## PLANNING REVIEW CHECKLIST

**Subject Property:** 4000 Deerhaven Dr NE

**Ref#:** 21-119953-RP and 21-119956-ZO

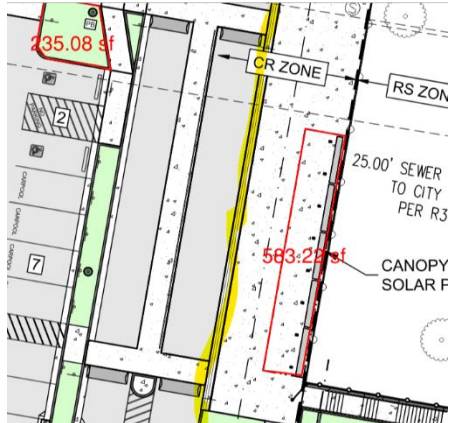
<p>- Please clarify what the yellow highlight structure is on the site plan, stairs?:</p> 
<p><b><u>Additional Land Use Applications Required (send application to <a href="mailto:kstraus@cityofsalem.net">kstraus@cityofsalem.net</a> for setup)</u></b></p>	<p>Validation of Units of Land (two properties)</p> <p>Property Line Adjustment or Replat</p> <p>Driveway Approach Permit</p> <p>Design Review – <i>As currently proposed, the project will require a Class 3 Design Review with a hearing in front of the Planning Commission.</i></p>
